MINUTES
**BOARD OF BUILDING STANDARDS/
ARCHITECTURAL BOARD OF REVIEW/SIGN REVIEW BOARD**
AUGUST 14, 2014
5:30 P.M. – Lakewood City Hall
Auditorium
(Audio Recording Available)

ARCHITECTURAL BOARD OF REVIEW

BOARD OF BUILDING STANDARDS

1516 Elmwood

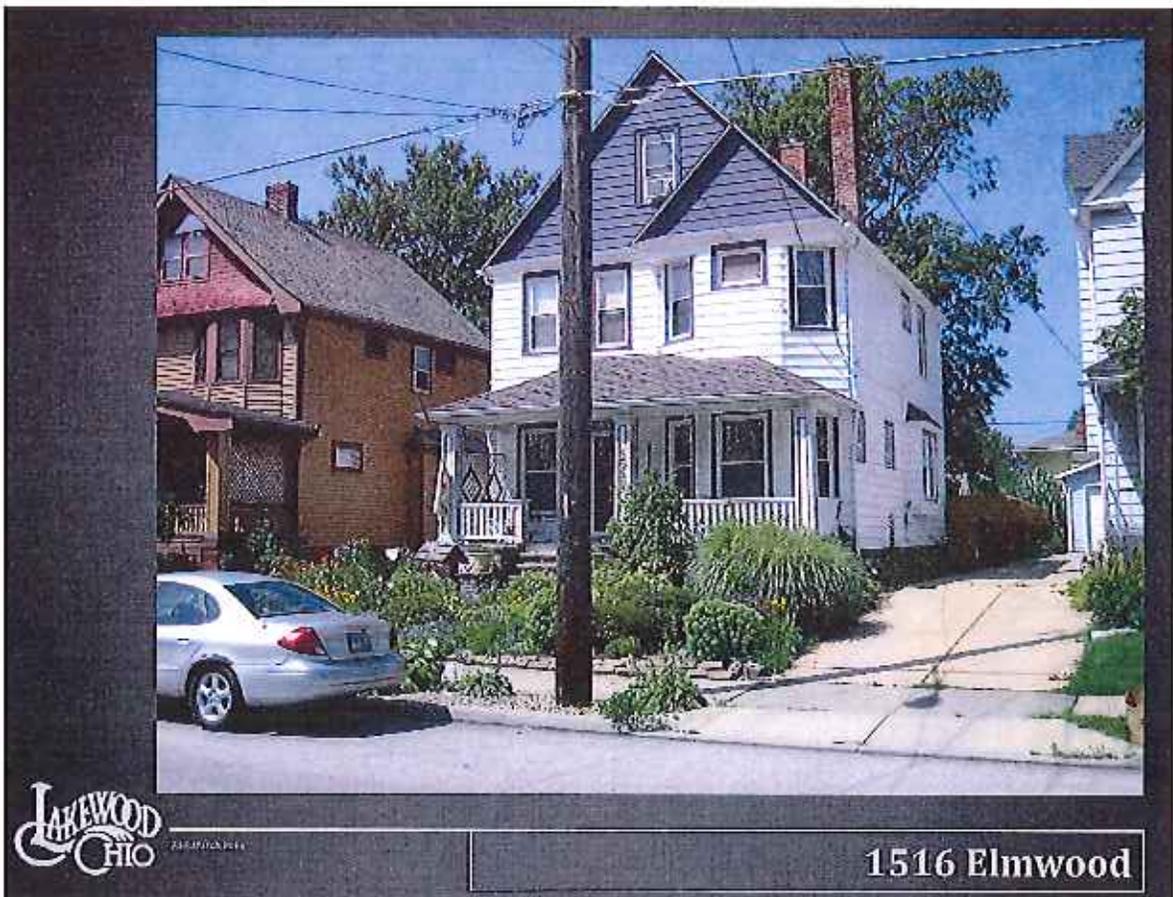
Brenda Mangini was present to explain the request. Her intent was to screen the rear neighbor's yard from her vision. The project was completed when the neighbor filed a complaint. Part of the wood fence was repaired at her expense and did not match the existing, so she attached the bamboo to both sides of it with staples.

The Board was not fond of multiple fences. Mr. Mofinski advised the Board that the applicant was cited for installation of a fence without obtaining a permit. The bamboo was attached to the neighbor's chain link fence. The bamboo fence was not standard material for permits. If the Board approved of the material, then a permit could be issued. Ms. Mangini thought the permit for the first fence was the only one needed; she did not know she needed a second one for the bamboo. The Board noted the top line was not straight. The bamboo was open to the elements and would splinter from freezing and thawing. The look was not one of permanence.

A motion was made by Mr. Orban, seconded by Mr. Evans to **DENY** the request. Ms. Stockman stated she approved the fence. With Mr. Evans, Mr. Musson, Mr. Orban, and Mr. Robar voting yea, and Ms. Stockman voting nay, the motion passed by a vote of 4 to 1.

1088 Lake Point Drive

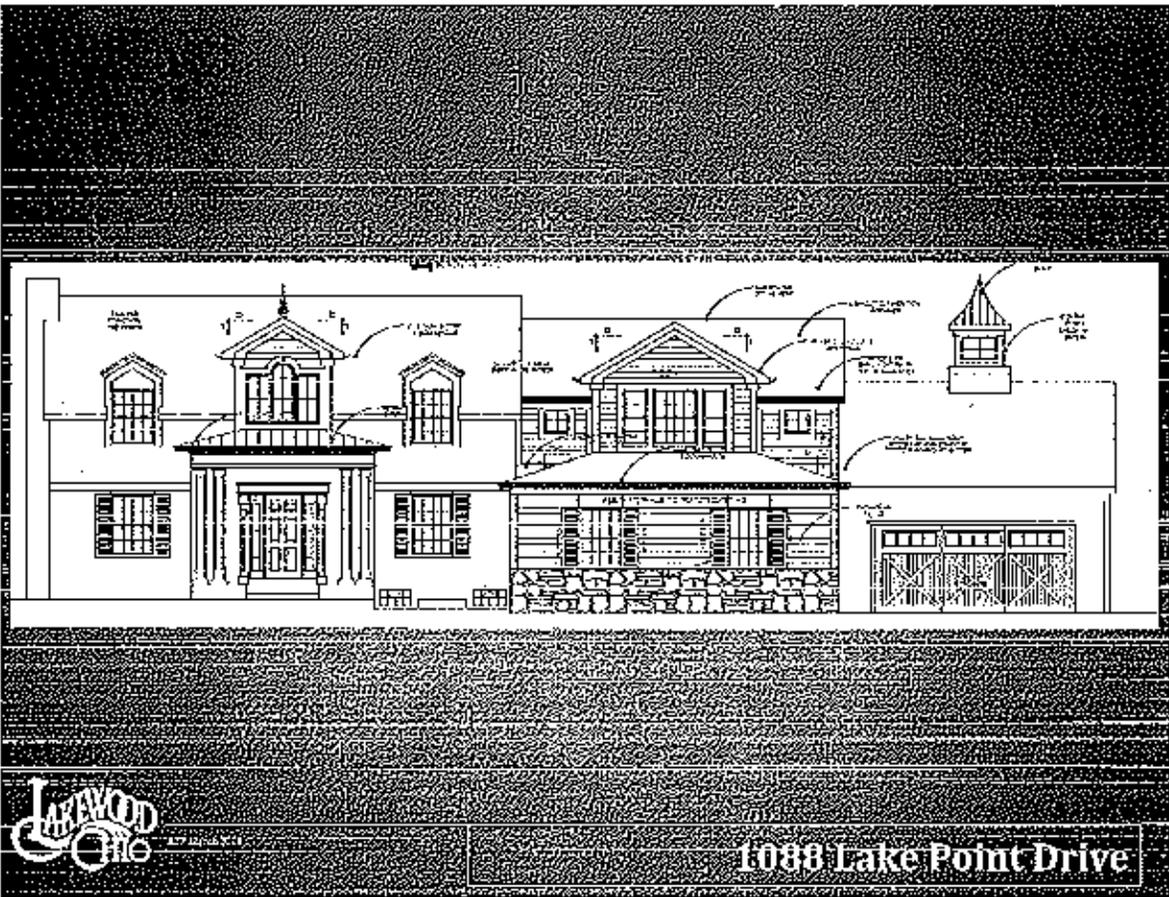
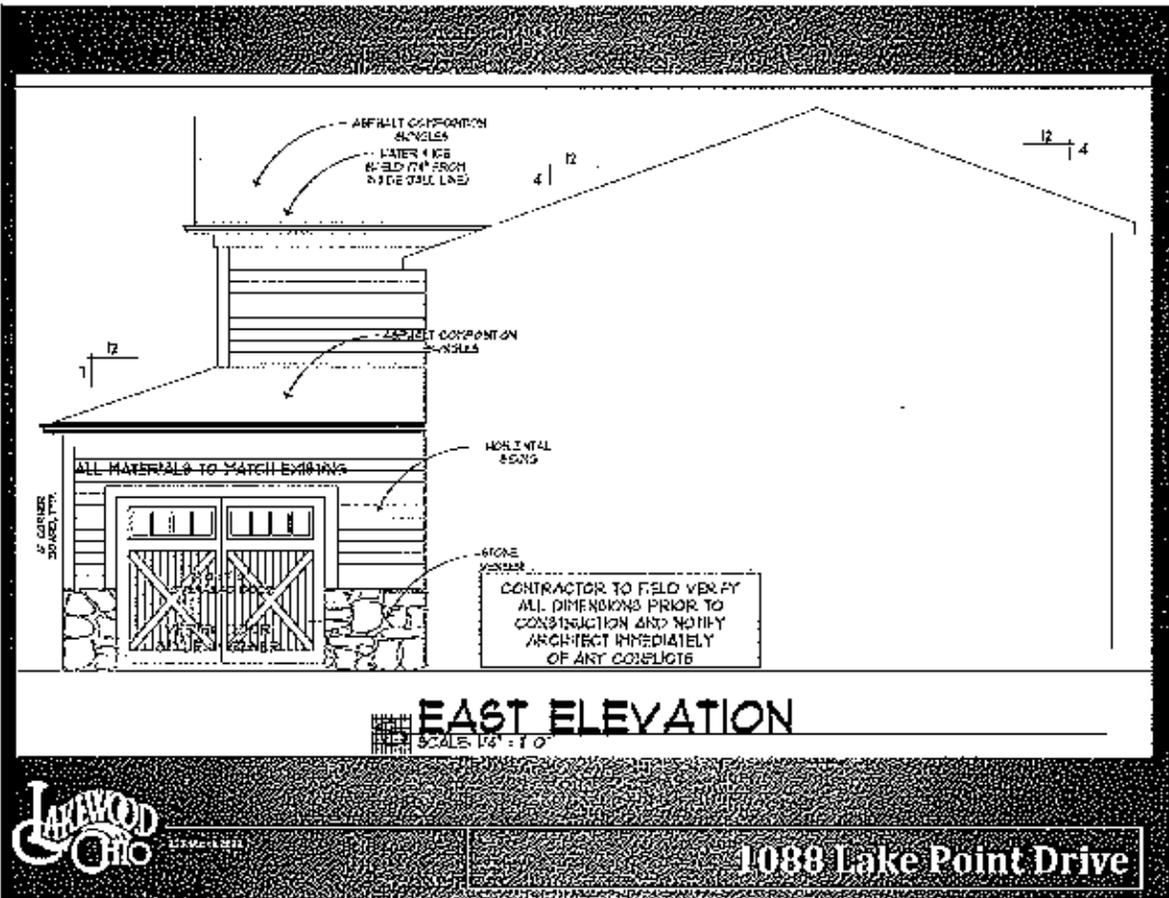
Stephen Schill, applicant was present to explain the request. The owner wanted to retain the stone that was on the garage but was willing to remove stone from the addition. Referring to the PowerPoint presentation, he described the roof and elevations. All of the materials would match the existing. Revised drawings were provided and discussed.

- Stone work will wrap the garage to match the front entrance of the home, and
- Stone work will not be used on the addition; clapboard siding to match the existing.

1295 Chase

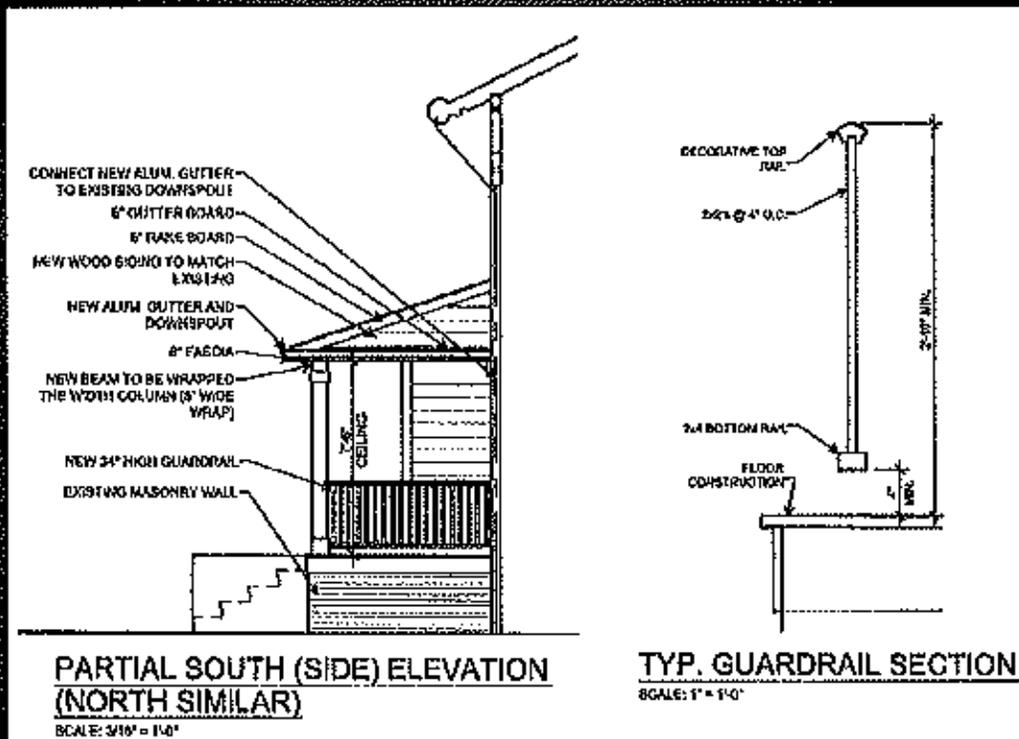
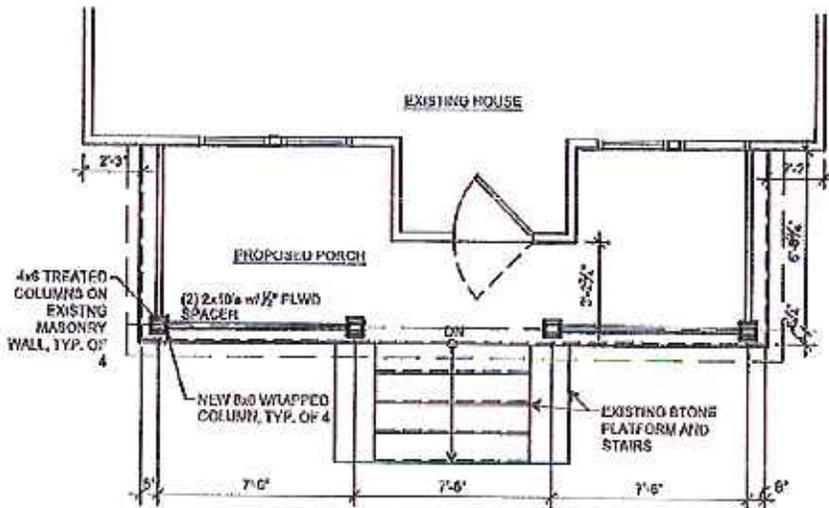
The Board agreed the look was appropriate.

Public comment was closed as there was no one to speak to the matter. For public record, Mr. Sylvester stated that all of the materials were wood.

- All of the materials are wood; not vinyl or metal.

1667-69 Waterbury

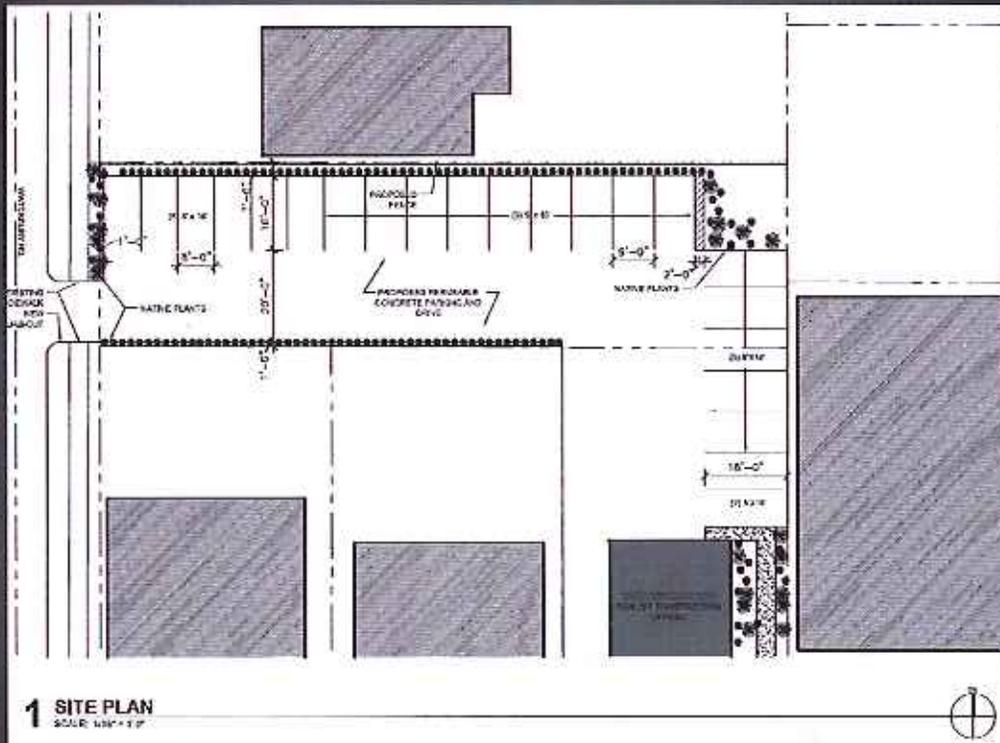
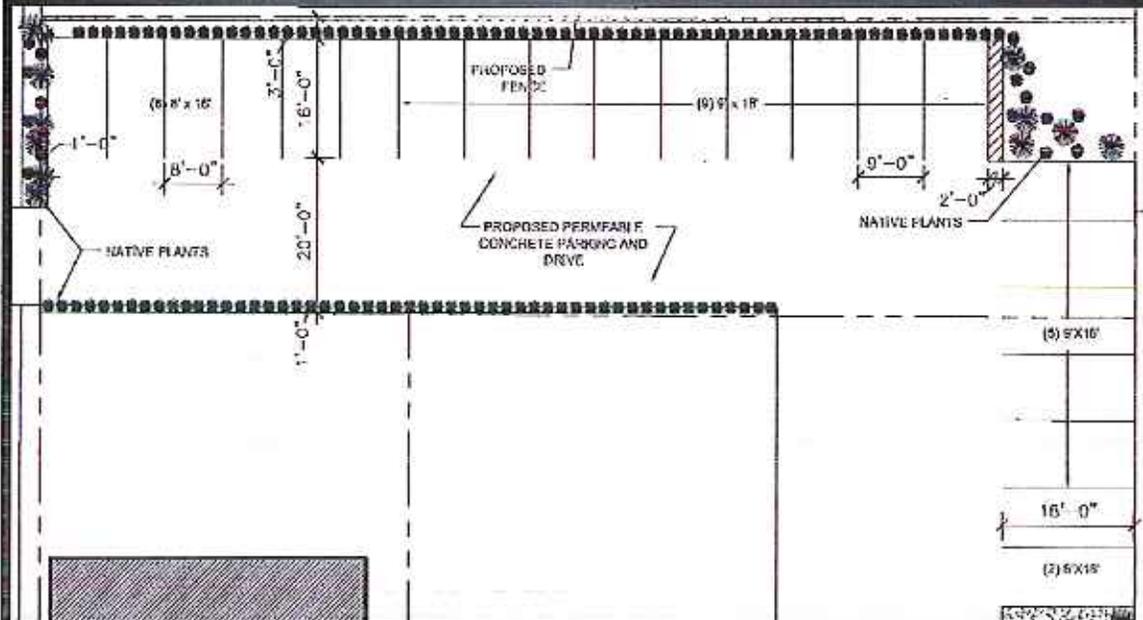
Frank Scalish, applicant was present to explain the request. He wanted to install a six-foot privacy board-on-board fence for screening on the north side that would match the fence to the south. There would be landscaping on the Waterbury Road side. Discussion continued about the curb cut, parking spaces, and traffic flow. City staff said that a buffer zone between the residential property and parking lot was paramount.

Daniel Szablewski, 1204 Andrews Avenue owned the two-family to the north of the proposed; 1663/1665 Waterbury Road. He was concerned about his tenants. The bedroom windows faced the parking lot. It suggested the planting of trees or limiting the parking during the day.

Public comment was closed as there was no one else to speak on the matter. City staff suggested the omission of the parking space closest to Waterbury Road and to add landscaping. Discussion ensued about the potential problems from snow plowing

- The western most parking space along Waterbury is removed,
- Installation of a five-foot buffer zone on the west side along Waterbury,
- Installation of a board-on-board fence from the setback of the house along the south property line along the back of the lot, and
- The board-on-board step-downs and landscaping plantings are reviewed and approved by the administrative staff.

12112 Madison

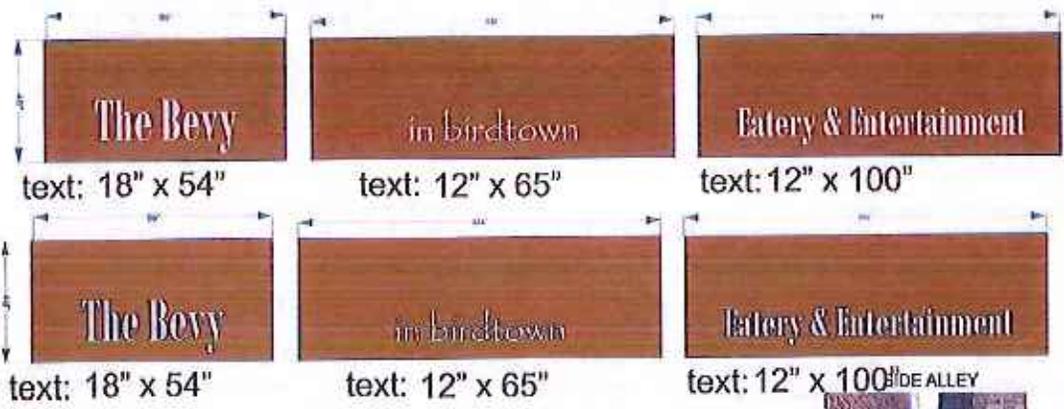
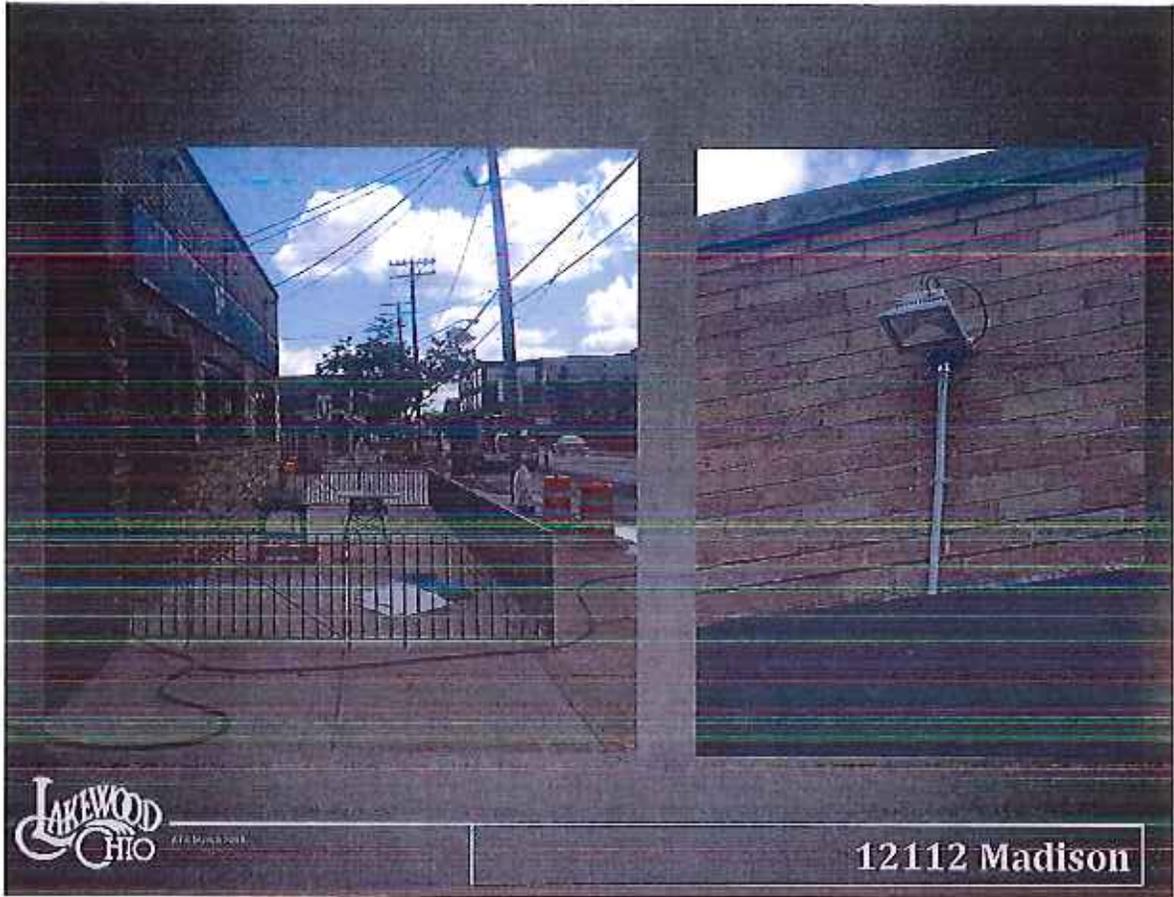
Patty Lim, applicant was present to explain the request. The fence around the patio was installed already. As far as the awnings were concerned, the Board felt there was too much verbiage on them. She estimated there would be about four inches of exposed conduit. Lighting had been mounted already; the Board said the type used was for a parking lot. The Board thought that one continuous awning would be more effective. The projection of the awning was five feet into the 11 foot deep patio. Discussion continued about the awning/awnings, verbiage, and lighting.

Public comment was closed as there was no one to speak on the matter. City staff concurred with the Board. Cut sheets for the furniture needed to be reviewed, the green colored fence was appropriate to the building, and the construction team was doing a great job.

- The awning is one continuous piece,
- The “Bevy in Birdtown” is on the left of the awning with the balance of the awning remaining blank or display a few birds (the verbiage “caterly and entertainment” are not permitted),
- That cut sheets for the furniture are submitted for administrative approval,
- And there is no lighting.

14879 Detroit

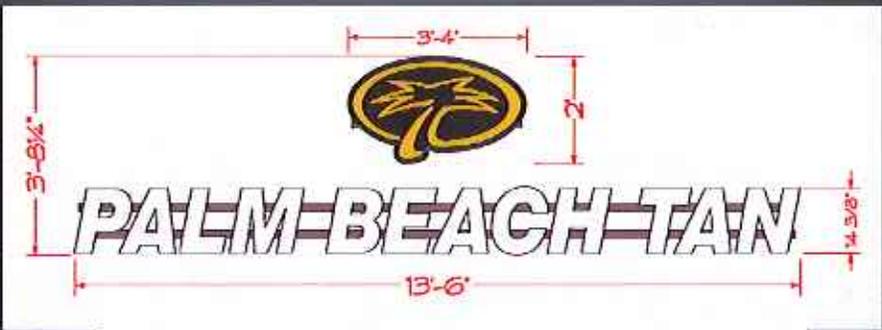
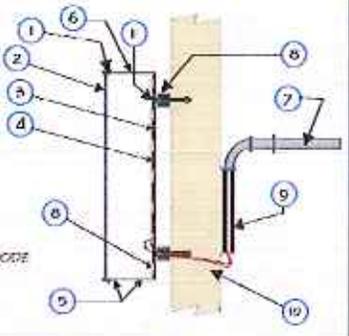
George Dragon, applicant was present to explain the request. The wireways and returns would be painted to match the brick, the background of the palm tree logo would be black, and the logo moved above the lettering.

Public comment was closed as there was no one to speak on the matter. City staff verified the returns would be black.
